SERVICE
1A2 KEY TELEPHONE SYSTEM
626A MODULAR PANEL

1.001 This addendum supplements Section 518-215-421, Issue 2. Place this pink sheet ahead of Page 1 of the section.

Fig. 8—FW Option

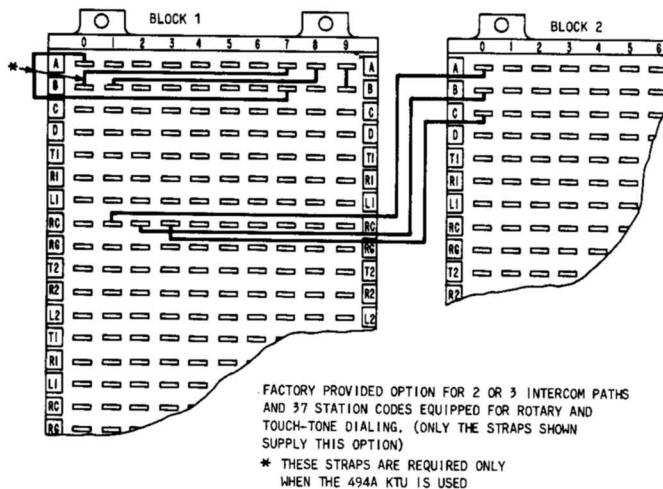
1.003 Issue 1 of this addendum was issued to correct Fig. 8 (FW Option) and Fig. 9 (S Option) and to show additional straps that are required when a 494A KTU is used.

2.001 On Page 11, Fig. 8 and 9 are obsolete. New Fig. 8 and 9 are shown in this addendum.
